Dresden Nuclear Power Station, Units 2 and 3
Facility Operating License Nos. DPR-19 and DPR-25

Subject: Request for Additional Information Regarding Risk-Informed Inservice
Inspection Program Relief Request

Response to Request for Additional Information Alternative to the ASME Boiler and Pressure Vessel Code Section XI Requirements for Class 1 and 2 Piping Welds Risk Informed Inservice Inspection Program

**Figure RAI 12-A Comparison of Inspection Effectiveness Factors for
EPRI RI-ISI Exams at DNPS Units 2 and 3**

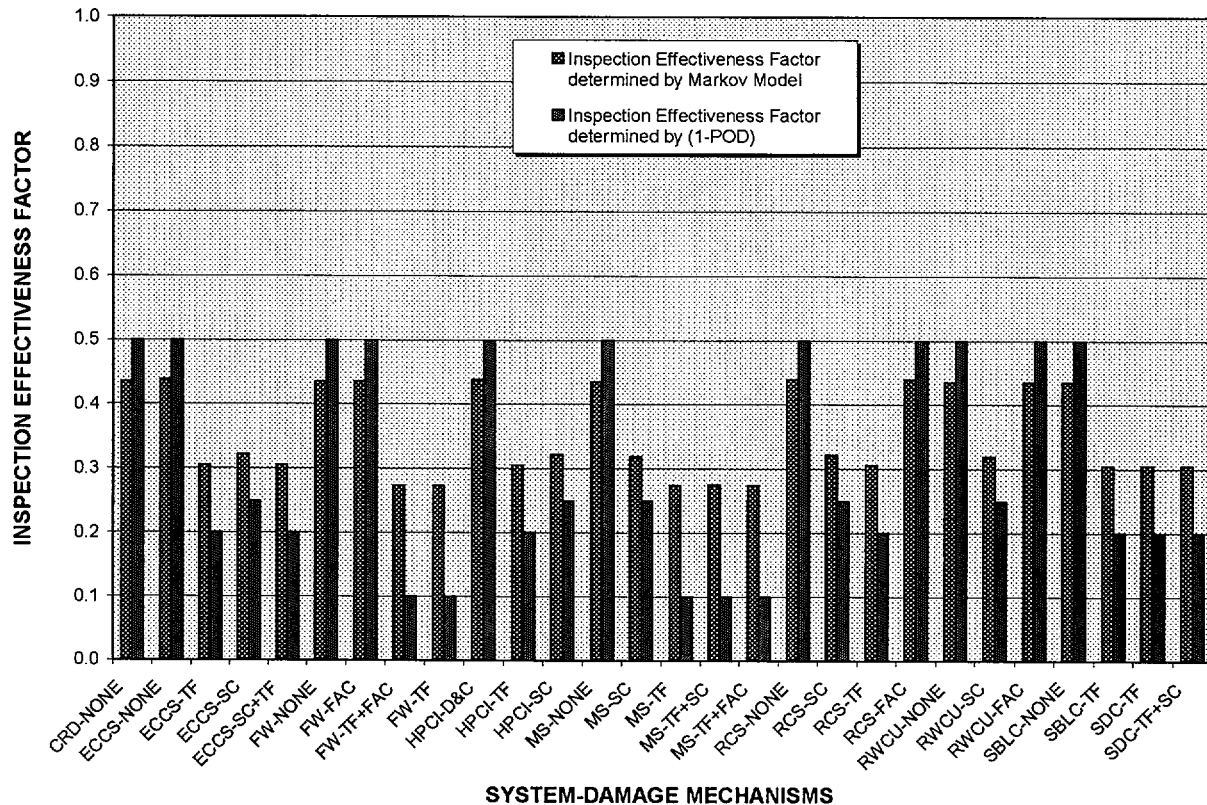
It is our understanding that you are calculating an "inspection effectiveness factor" for use in equation 3-9 of EPRI Topical Report (TR) 112657. Please provide the distribution of inspection effectiveness values calculated (clearly identifying the upper and lower bounds) and a discussion on how these values compare with other probability of detection estimates (redefined to the same format).

A tabulation of all the unique inspection effectiveness factors for all pipe segments evaluated within the scope of the RI-ISI evaluation for DNPS Units 2 and 3 is presented in Table RAI 12-A. For comparison purposes, the corresponding POD values that were used were presented along with their complements that provide the alternative method of computing the inspection effectiveness factor. A plot that compares the two approaches to computing the inspection effectiveness factors is provided in Figure RAI 12-A for the RI-ISI exams.

As seen in these exhibits, there is fairly good agreement between these alternative approaches to estimating the inspection effectiveness factors. When the POD values are around 0.50, the Markov model predicts a somewhat higher level of inspection effectiveness, as reflected in somewhat lower inspection effectiveness factors. For higher POD values, the Markov model predicts a somewhat lower level of inspection effectiveness, as reflected in somewhat higher inspection effectiveness factors. Details documenting the inputs to computing these factors are discussed in response to RAI 11.
